APPENDIX D: NIAGARA REGION WIND FARM ACOUSTIC ASSESSMENT REPORT – REA AMENDMENT

Niagara Region Wind Farm
Acoustic Assessment Report – REA Amendment

File No. 160961052
–(160950269)

April 08, 2016

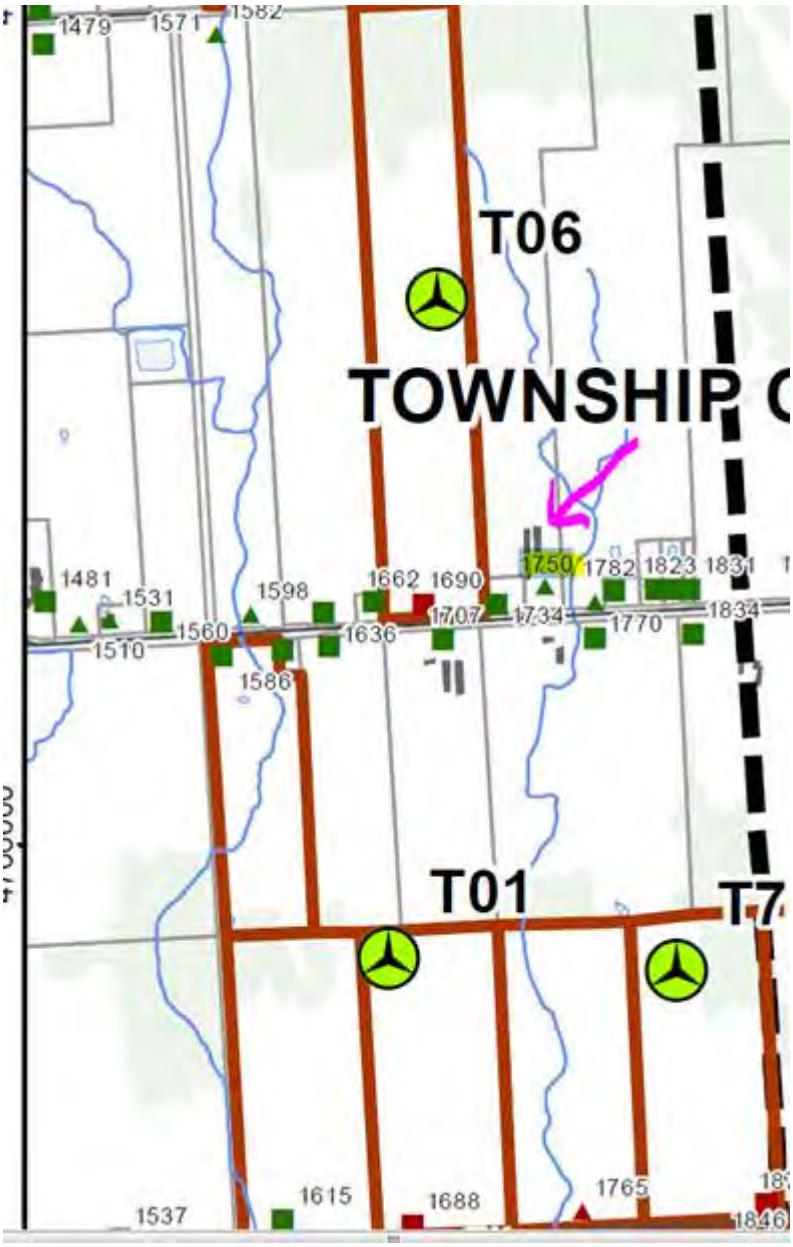
Please provide rationale why this receptor was deemed to be a vacant lot.

Based on our review of the current aerial photography, field verification during the initial development of the noise model to identify POR's, and review of building permits prior to issuance of the draft site plan, this property is a vacant property. Based on our information, there is no existing dwelling on this property (see Photo 2) and no dwelling was approved prior to the issuance of the draft site plan. As such, a vacant lot receptor (V_794) was appropriately located on the subject property within the noise model. The existing dwelling to the east of receptor V_794 is located on a separate parcel of land and represented by receptor O_3887. Both receptors comply with the minimum distance from a turbine and the noise threshold.

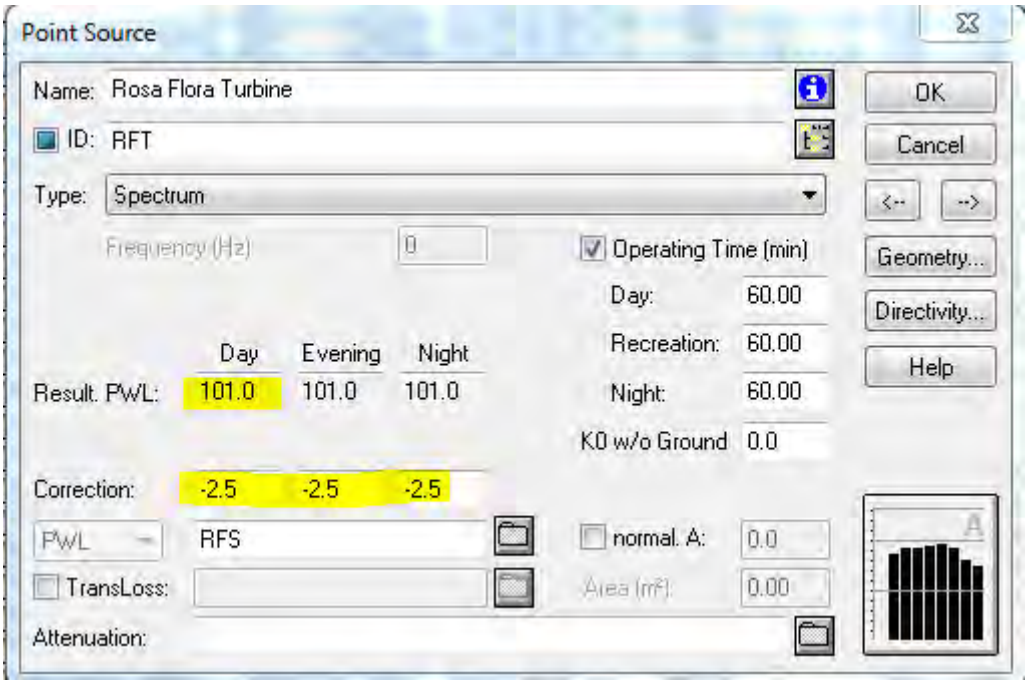
The Cadna files note the following sound power level (101.0 dBA) for Rosa Flora Turbine:

The Noise Report notes the following sound power level (104 dBA) for the same turbine .

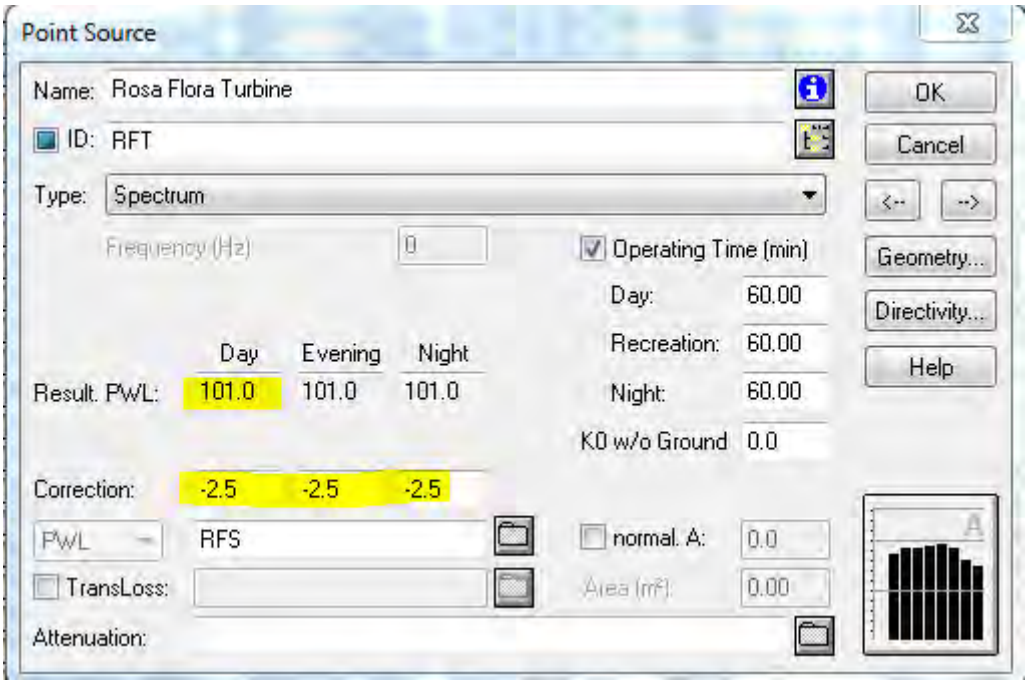
The Cadna files note the following sound power level (101.0 dBA) for Rosa Flora Turbine:

The Noise Report notes the following sound power level (104 dBA) for the same turbine .
